RE: Hydrogen Energy California Project
Application for Certification 08-AFC-8

Responses to CEC Data Requests Set One (#1-132)

Revised Application for Certification (08-AFC-8) for HYDROGEN ENERGY CALIFORNIA Kern County, California

Figure 18-1
Particle Size as Function of Droplet Size

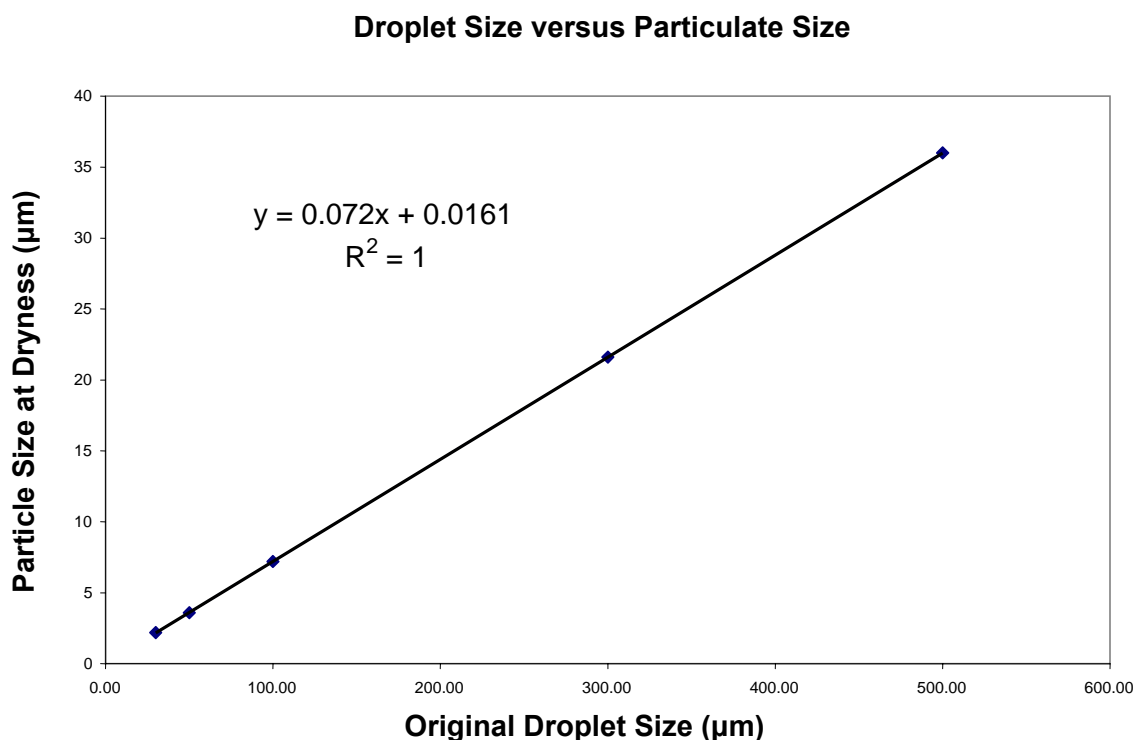
A U.S. EPA report provided a calculated estimate on the effect of evaporation on droplet size, which presented an equivalent PM size generation as a function of droplet size (U.S. EPA, 1998) (see Figure 18-1 and Attachment 18-1).

Figure 18-2
Particulate Mass Distribution Curve (U.S. EPA)

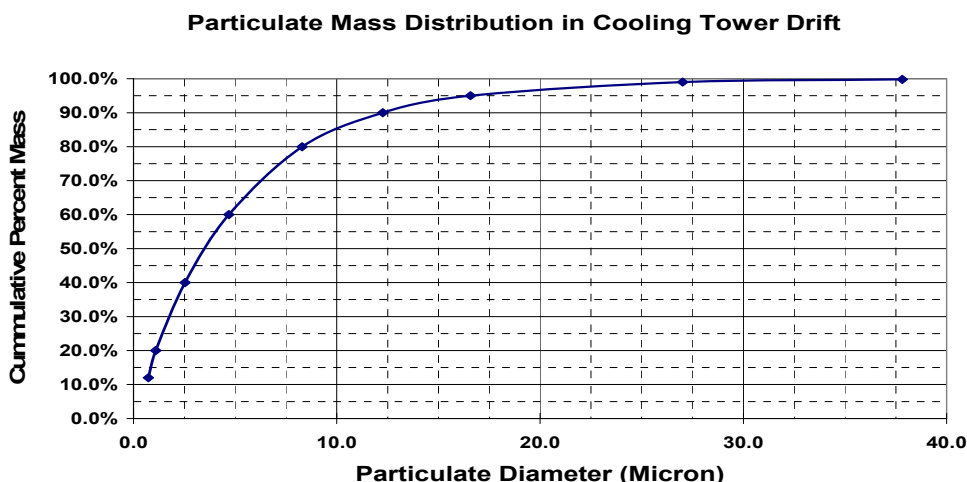
A plot of particle distribution based on the last column of Table 18-2 is shown in Figure 18-2.

As shown in Figure 18-2, $PM_{2.5}$ emissions from cooling tower drift using the U.S. EPA methodology are approximately 40 percent of the total particulate emissions. Figure 18-2 shows that the HECA Project's assumption that $PM_{2.5}$ emissions are 60 percent of the PM_{10} (which was assumed as 100 percent particulates) is indeed conservative.

Figure 18-3 Particulate Mass Distribution Curve

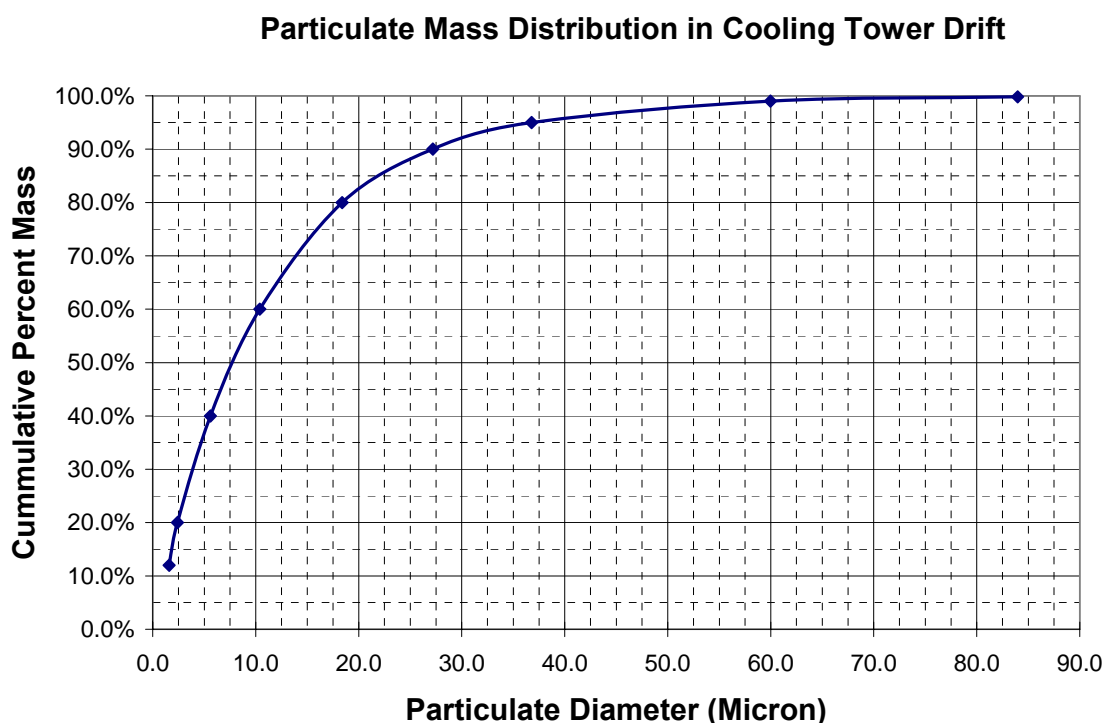
A plot of the last column in Table 18-3 is shown in Figure 18-3.

Using the second approach based on droplet size from the cooling tower manufacturer, and the approach by Aull (1999), $PM_{2.5}$ emissions from cooling towers is approximately 20 percent of the total particulate emission. This approach showed that the HECA Project's assumption that $PM_{2.5}$ emissions are 60 percent of the PM_{10} (which was assumed as 100 percent particulates) is far more conservative than the expected value.
